HOPE CREEK GENERATING STATION  
DOCKET NO. 50-354  
REVISED FSAR QUESTION RESPONSES

Attachment I contains the revised responses to FSAR Question 410.69 and 430.88. In addition, attached to 430.88 is one copy of "Summary of Reduced Standby Diesel Generator Loading to accommodate a standing hurricane after a Loss of Offsite Power." These question responses were revised per discussions held with the auxiliary system and power system branches respectively.

ATTACHMENT I

FIGURE 430-88-1

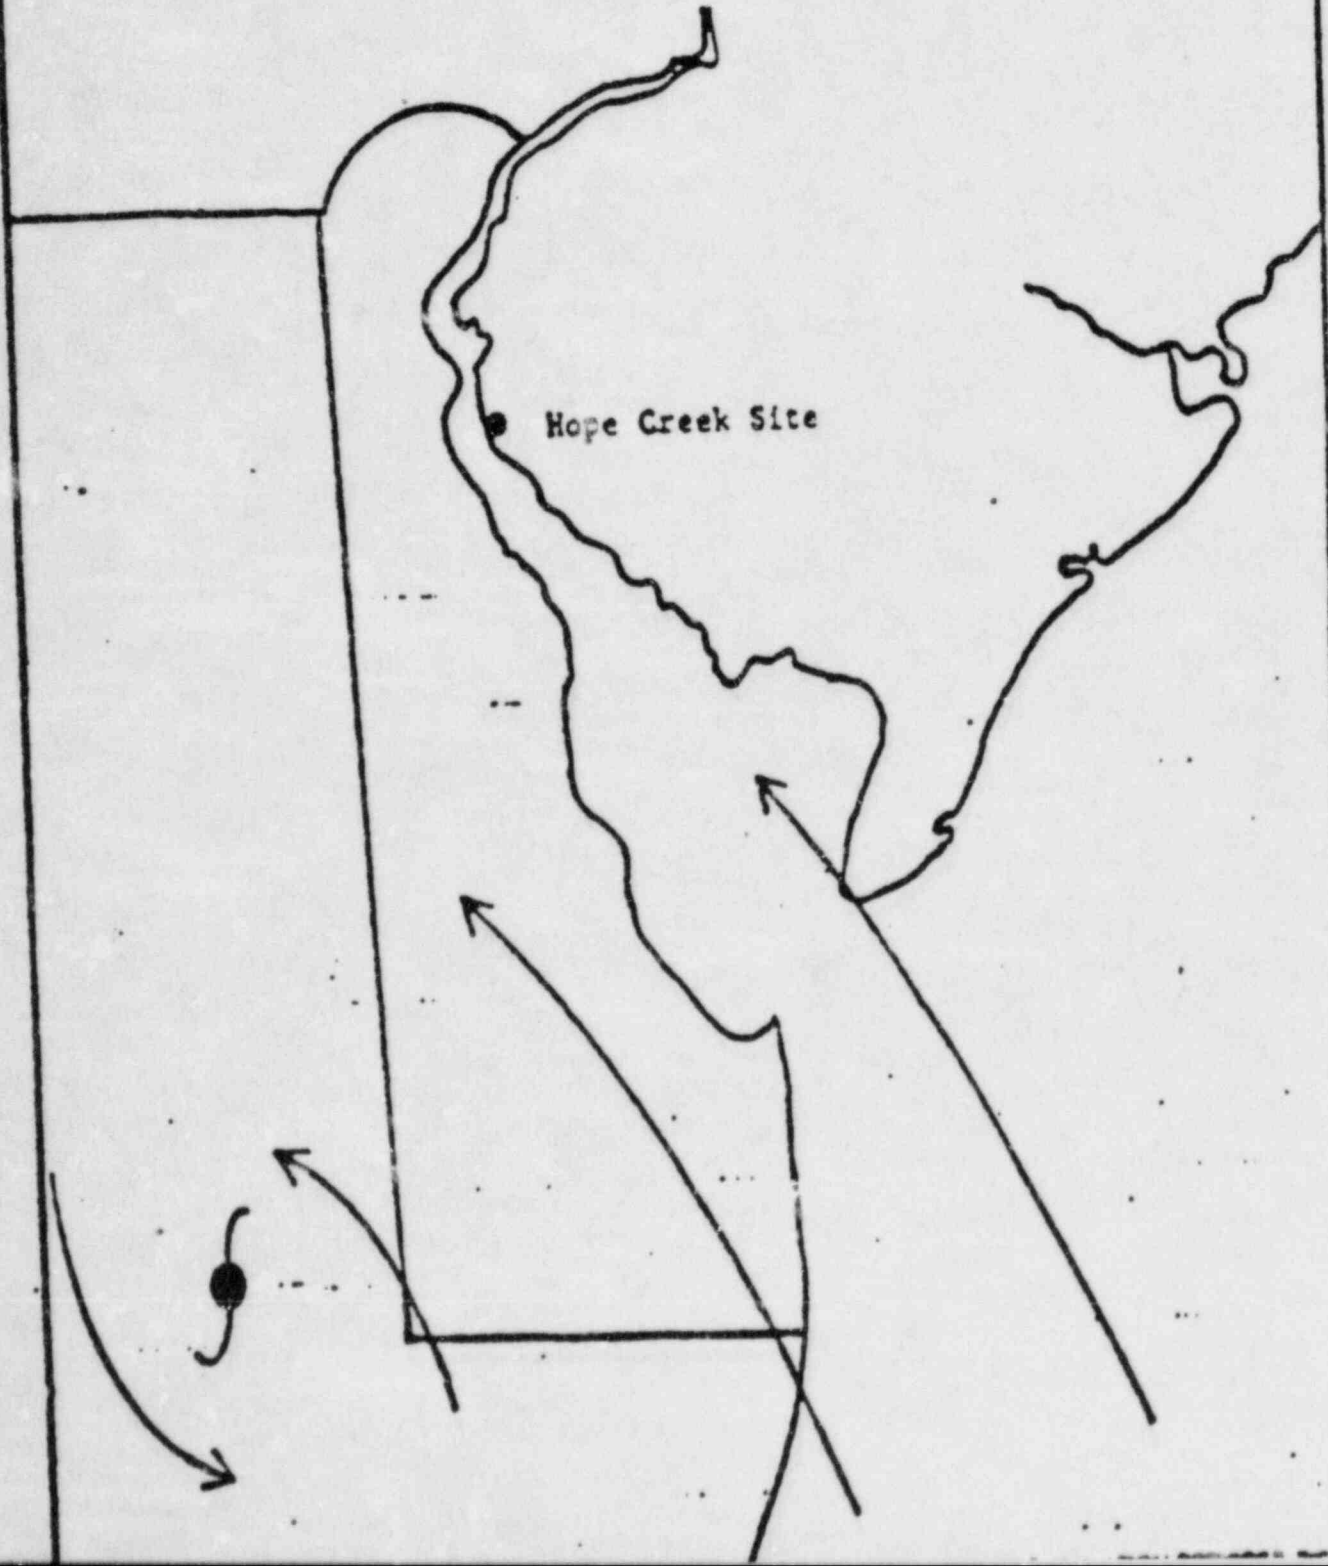
Provide additional justification to support your statement in Section 9.5.4.3 that sufficient additional fuel can be delivered to the plant site by truck, or barge. In your discussion include sources where diesel quality fuel oil is available and distances travelled from the source to the plant. Also discuss how fuel oil will be delivered onsite under extremely unfavorable environmental conditions. (SRP 9.5.4, Part I)

A. Hurricane stationary in the least favorable position (see Figure 430.88-1)

A hurricane in this position is largely cut off from oceanic moisture and it is subject to frictional erosion of its wind speeds. It will decay into a wet, showery situation with modest wind speeds within 12-24 hours.
